Response to Submissions Report

Ash Recycling Facilities, Eraring Power Station

Client: Origin Energy Resources Limited

AECOM Australia Pty Ltd

Figure 7 Proposed site layout for modification area 2

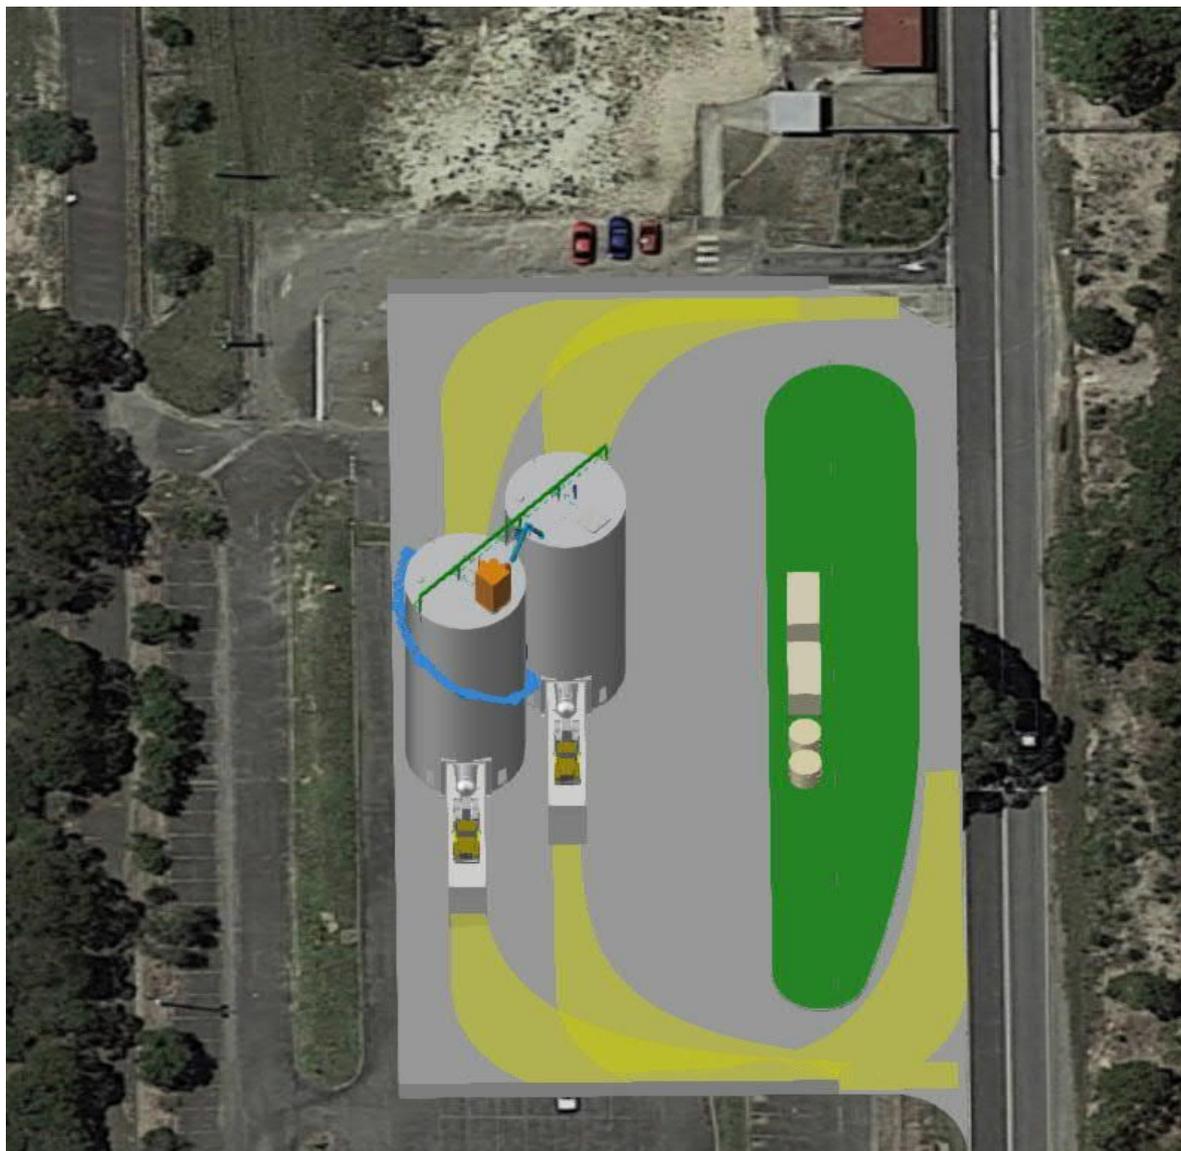
- Internal manoeuvring – vehicle paths within the new silo area are not clearly defined as the receiving vehicle is either turned on site or is allowed to exit on another access point where the plant is positioned against Construction Road. Clear detail is required on how internal site manoeuvres would be achieved;

The proposed vehicle paths for the revised configuration of the additional silos at modification area 2 are shown in **Figure 7**. Trucks would enter the site from Construction Road via the existing entrance at the northern end of the site. Once trucks are loaded at the silos, they would exit onto Construction Road via a new access point at the southern end of the site. All traffic movements would follow a one-way counter-clockwise direction, with no trucks being turned on site.

Figure 8 Modification area 2 – indicative dimensions for 1000t ash storage silos

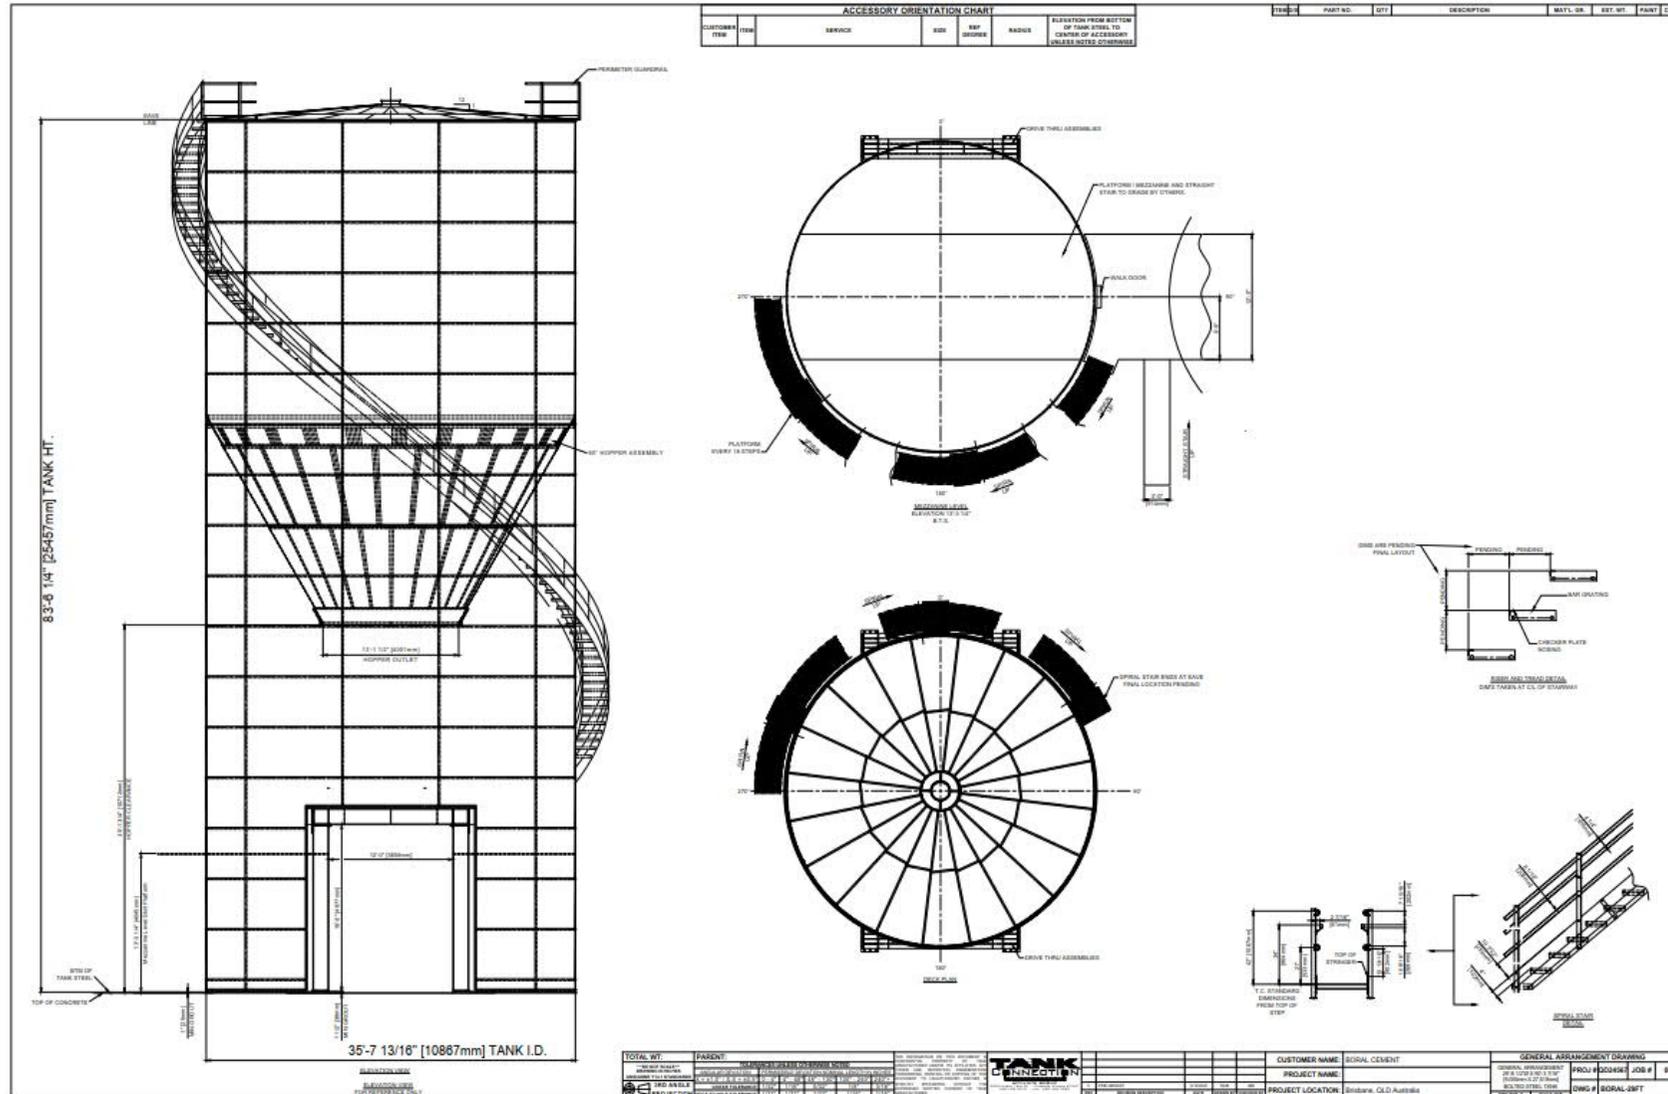
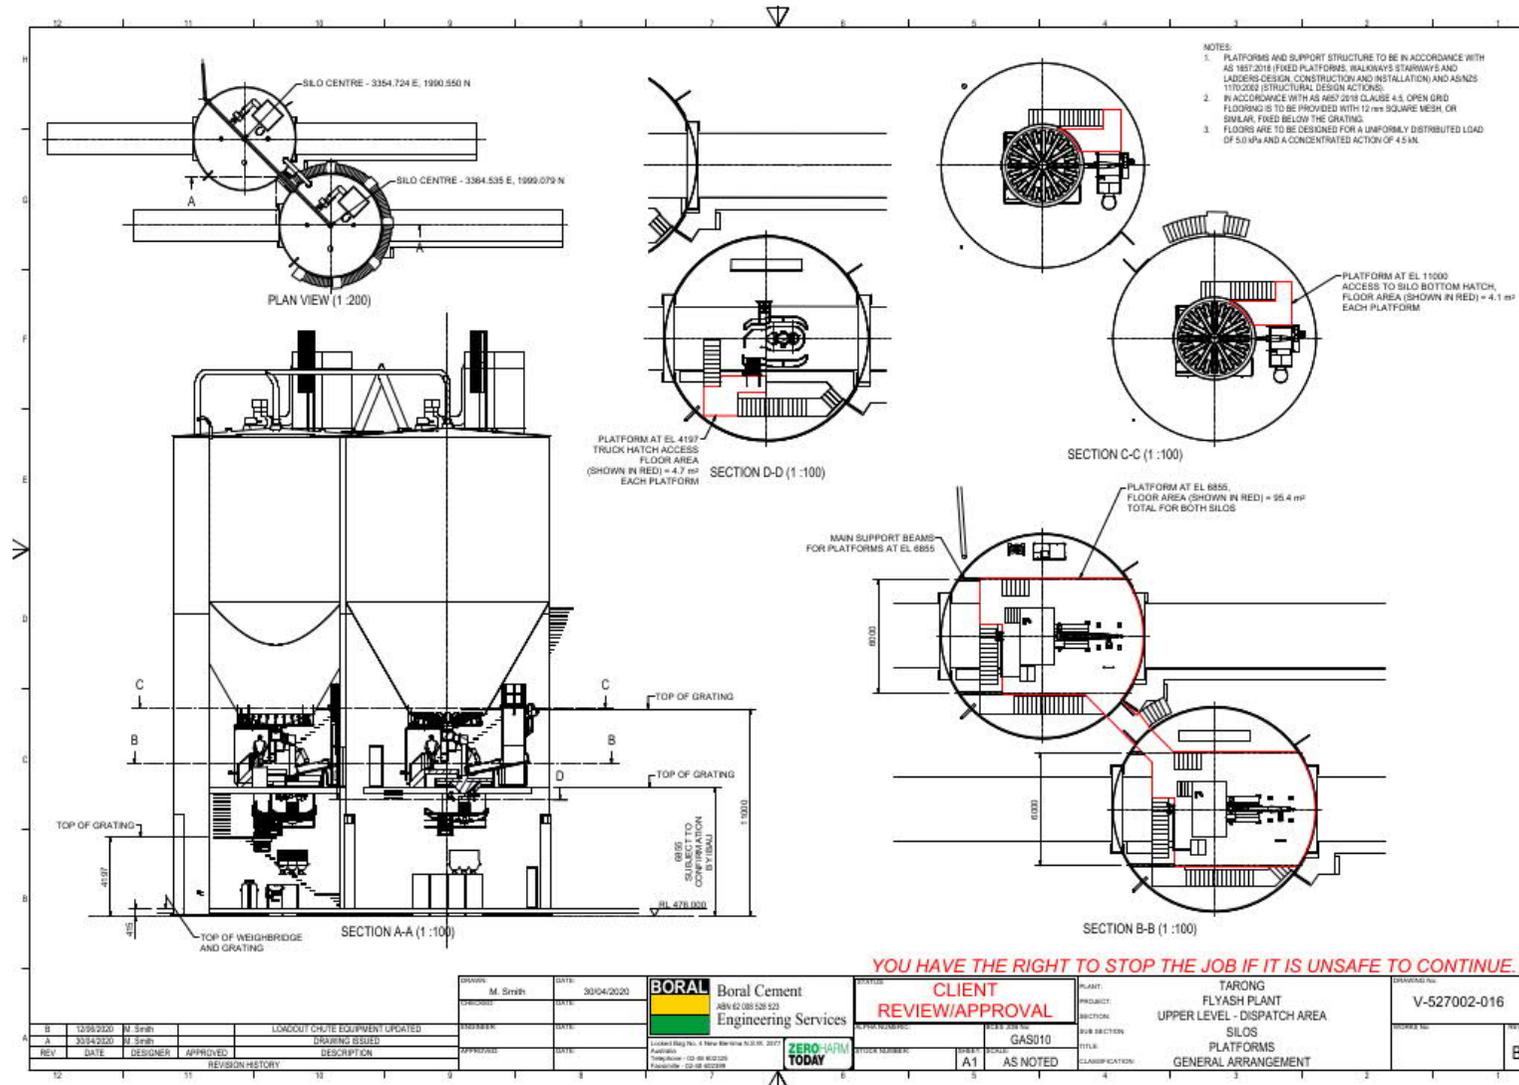
As described in the Modification Report, the proposed modification included up to four additional 600t ash storage silos at modification area 2 (as shown on **Figure 3**) to be operated and maintained by a third party up to approximately 150,000 tpa.

The configuration of these silos may be amended with an alternative potential layout option for modification area 2, to include two 1000t silos. The proposed site layout and design drawings for the alternative silo configuration are shown in **Figure 7** to **Figure 9**.

The alternative configuration is not expected to significantly impact the scale of the operation or infrastructure at the site. The proposed throughput would not change and is still proposed to be up to approximately 150,000 tpa. The indicative dimensions of the 1000t silos (shown in **Figure 8**) would be approximately 25.5m height and approximately 10.9m diameter. These dimensions are relatively comparable to the indicative dimensions provided in Figure 10 of the Modification Report (for silos from a similar reference site) of approximately 24.8m height and approximately 6.5m diameter.

Figure 2 - Nearmap aerial from 1st August 2021 indicating 170 metres sight distance

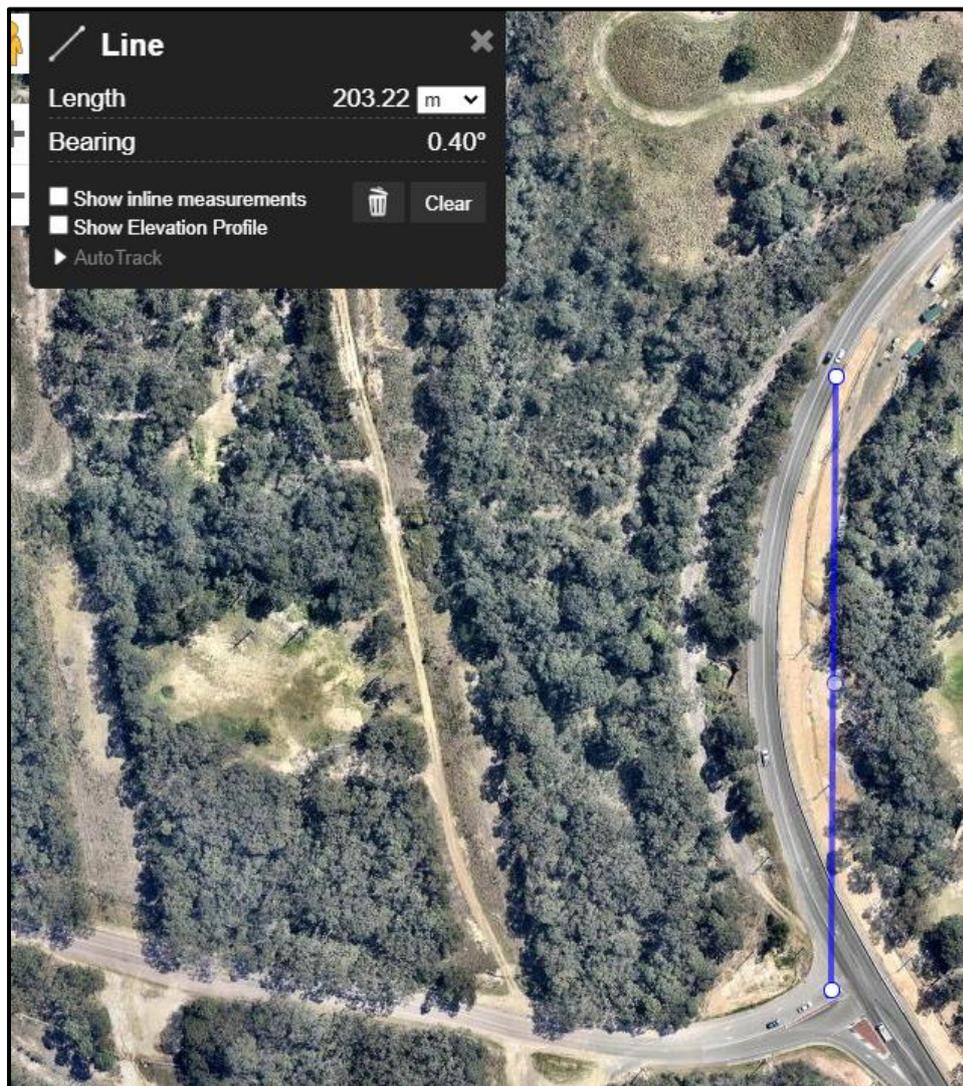
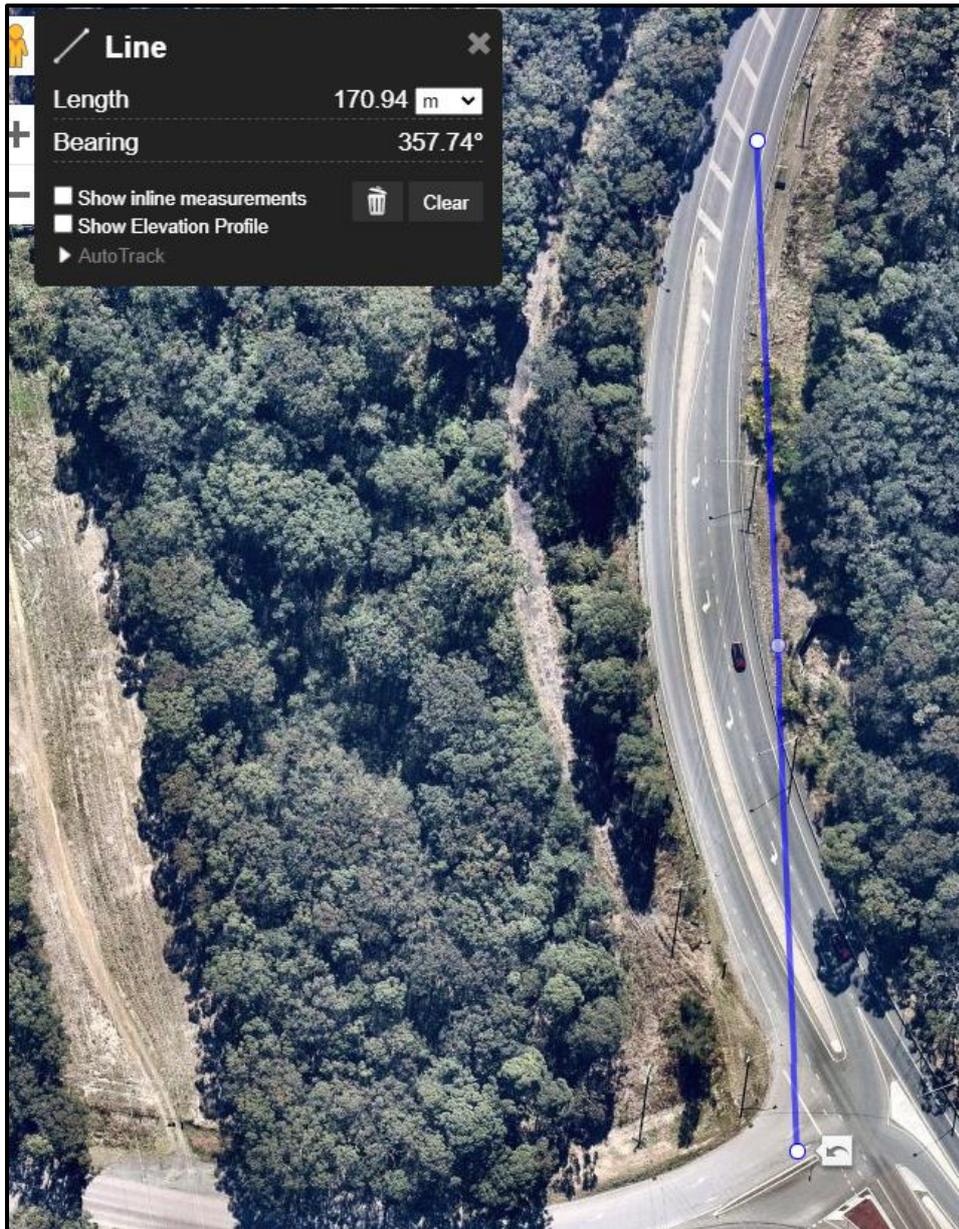
SECA reviewed the layout of the Wilton Road/Wangi Road intersection, including the length of acceleration lanes and available sight lines, and reviewed accident data for the intersection over a five year reporting period.

- Visibility to left for a driver exiting Wilton Road is approximately 170 metres.
- Visibility to the right for a driver exiting Wilton Road is approximately 340 metres.

Austroads Guidelines state that for the posted speed limit of 80 km/h the Safe Intersection Sight Distance is 170 metres desirable and 151 metres minimum. A review of Nearmap images shows that in October 2016 when TfNSW completed an upgrade at this intersection (to provide the right turn out of Wilton Road acceleration lane) there was significant vegetation trimming within the road reserve to the immediate north of the intersection. This would have allowed for increased forward visibility for drivers on Wangi Road as well as improved safe intersection sight distance for drivers exiting Wilton Road. Refer to the two images below.
